ADDENDUM NO. 1

DATE: February 20, 2026
FROM: City of Grand Junction Purchasing Division
TO: All Offerors
RE: Stocker Stadium South Concession Renovation RFQ-5851-26-DD

CONCOURSE PLAN

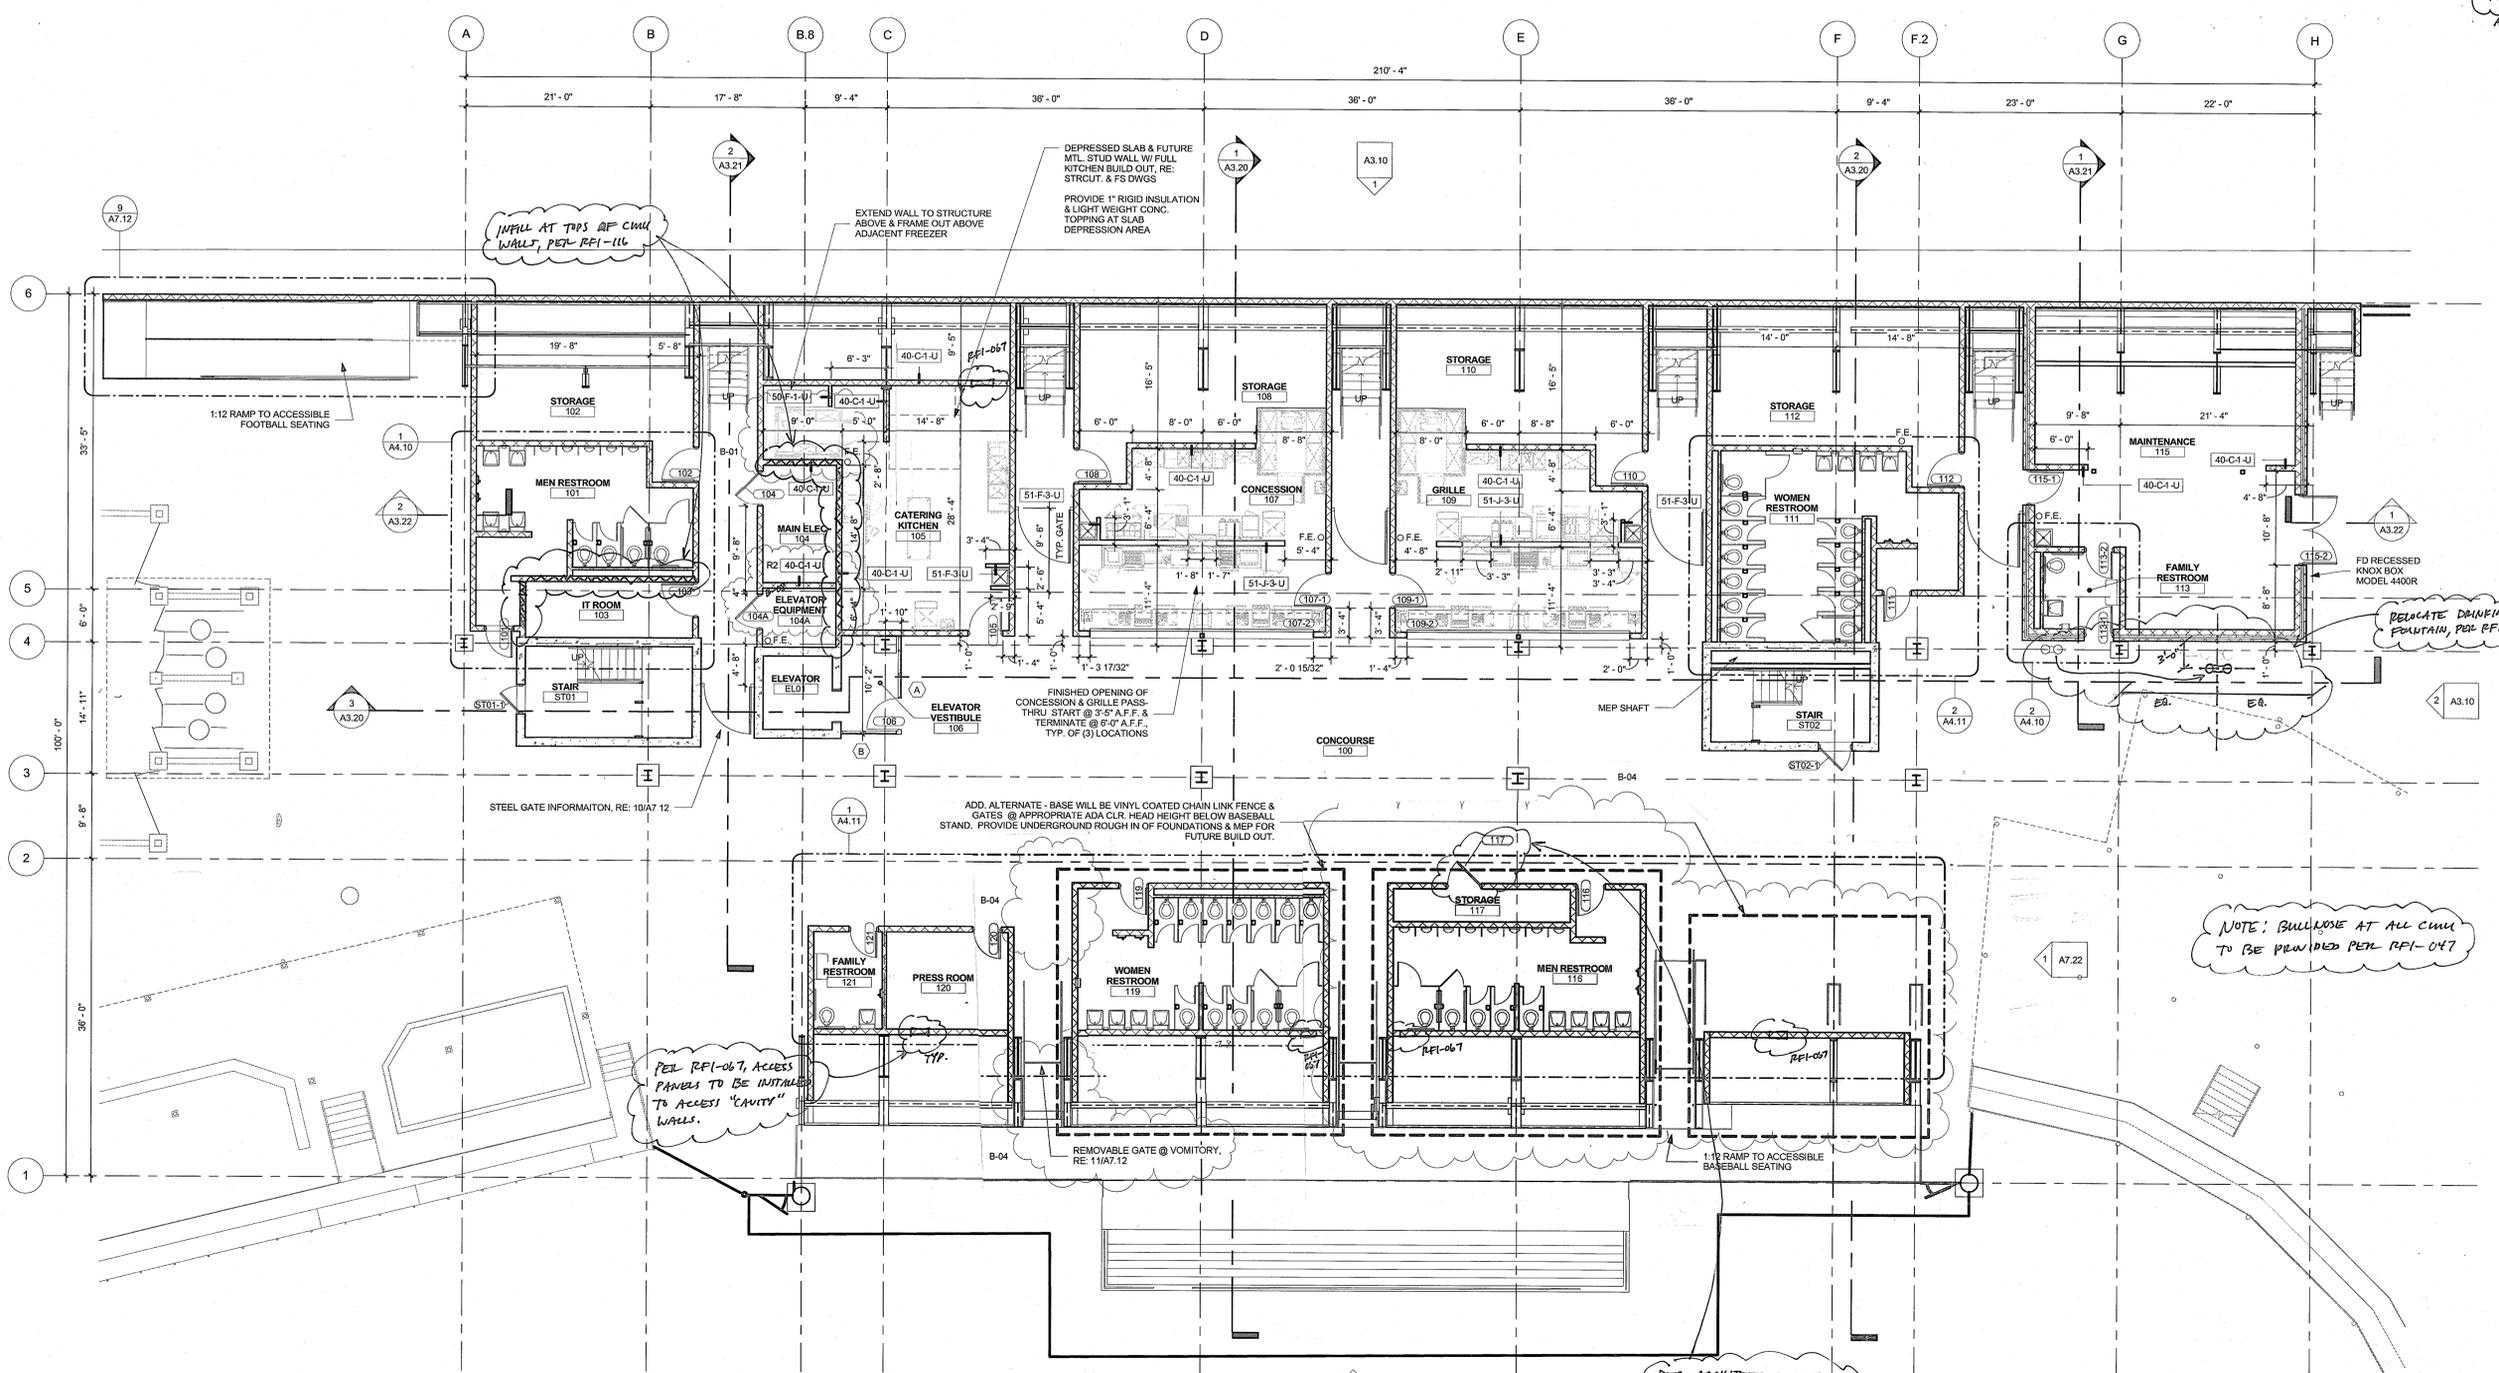
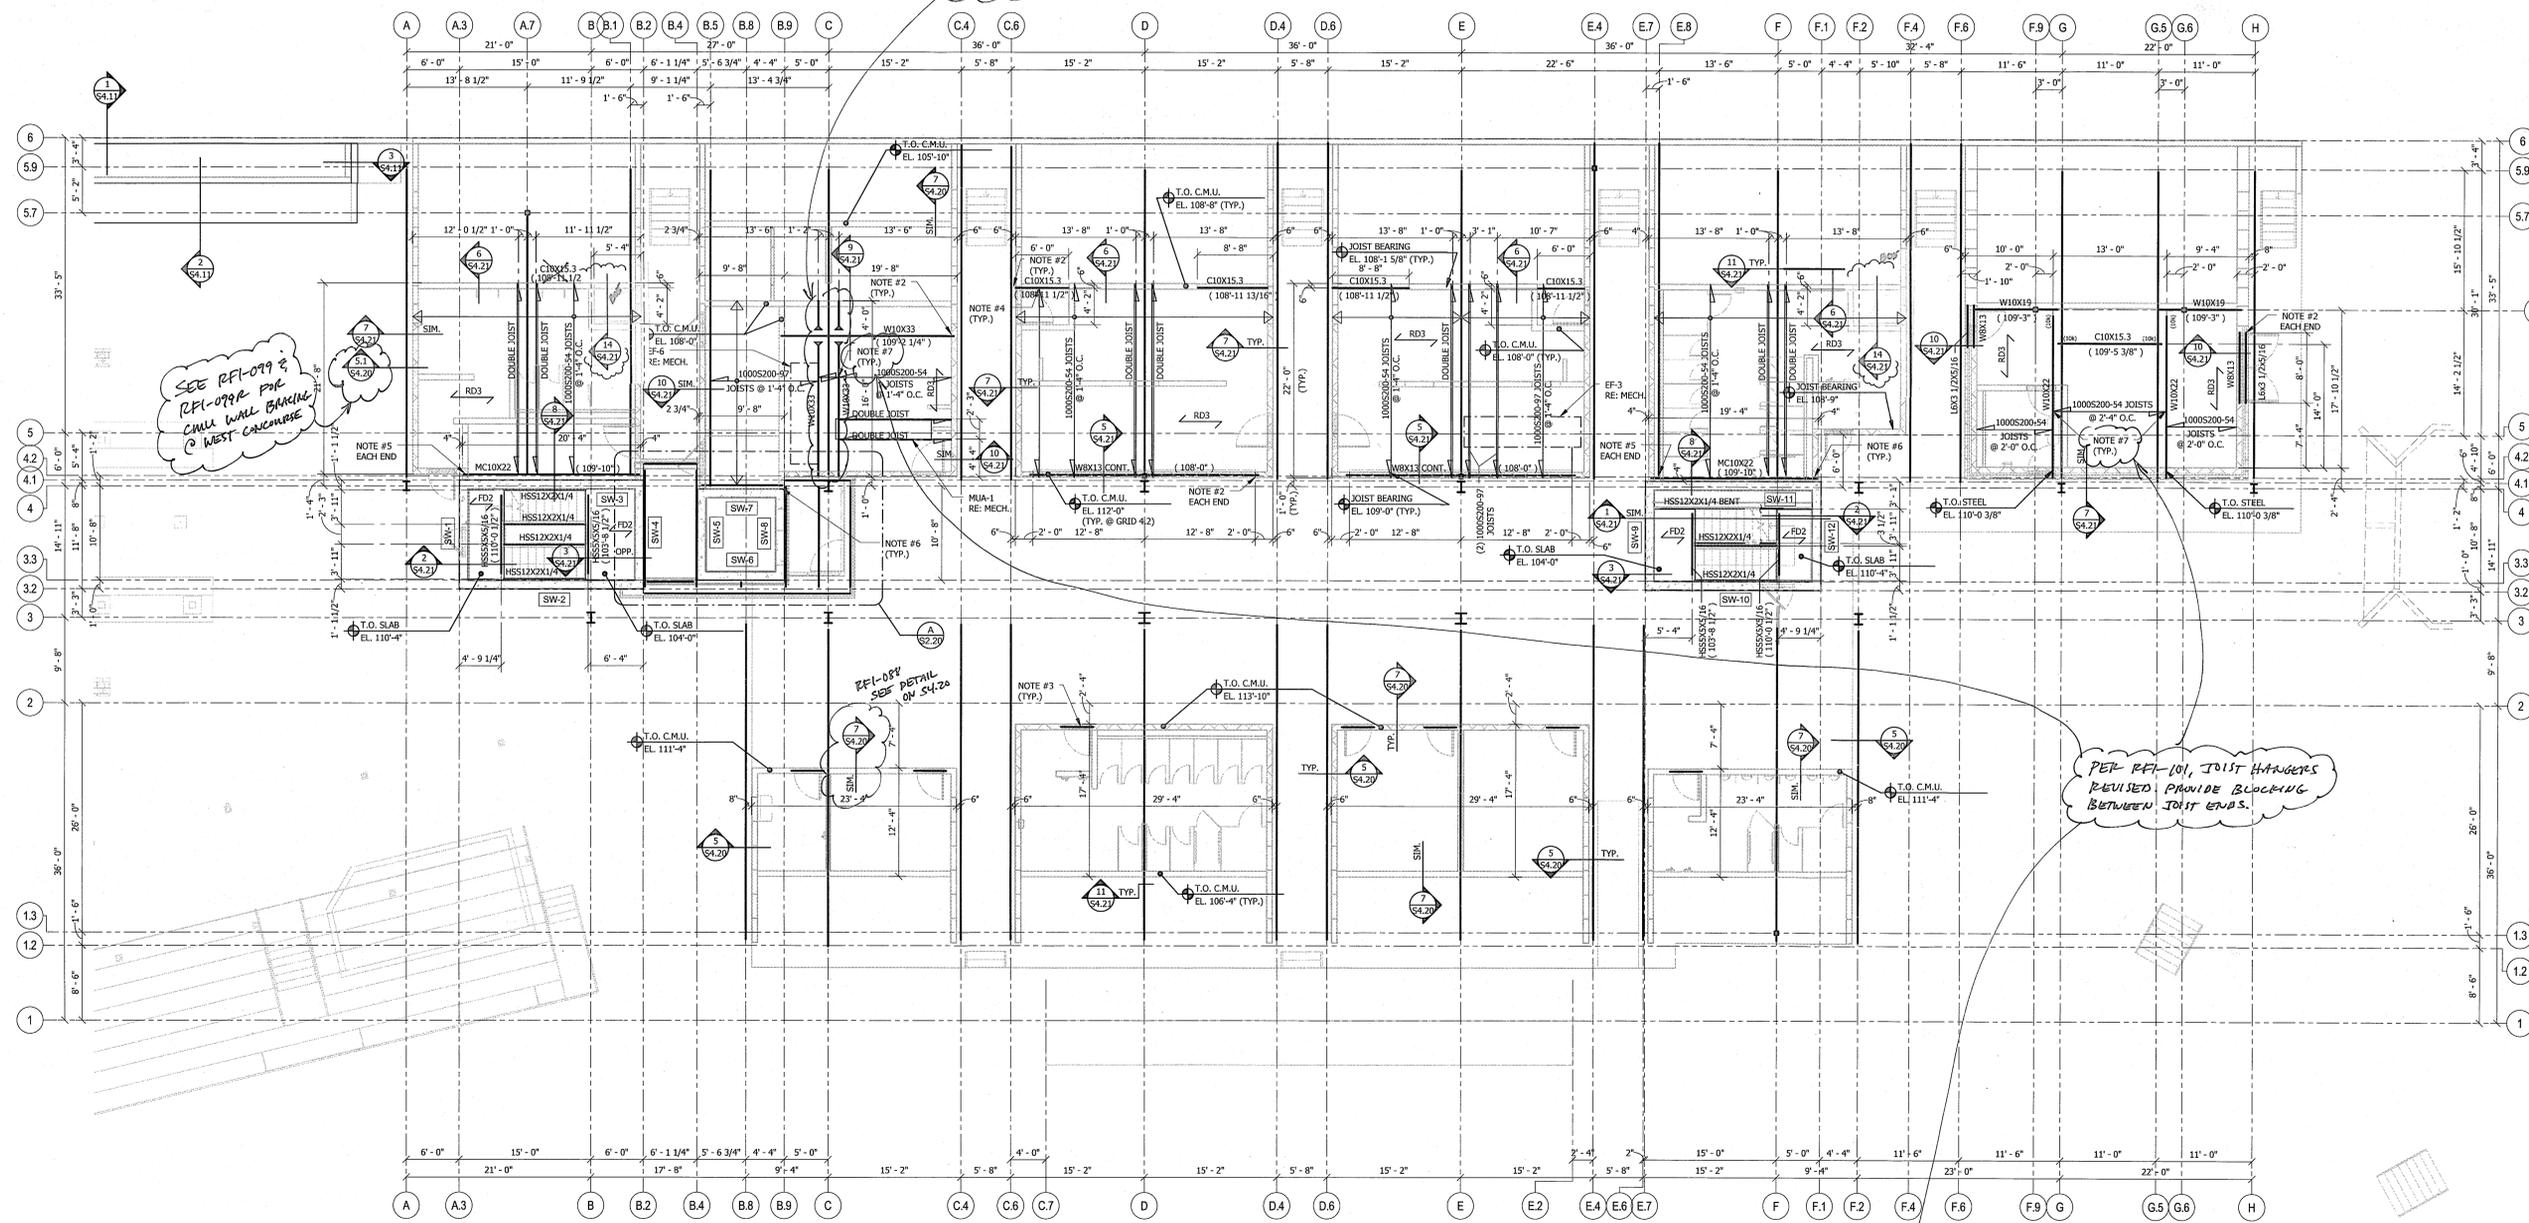
PER RFI-070, SHIRT WALLS ADDED AT THE TOP OF THE LOW ROOFS TO BETTER TERMINATE ROOFING MATERIAL.
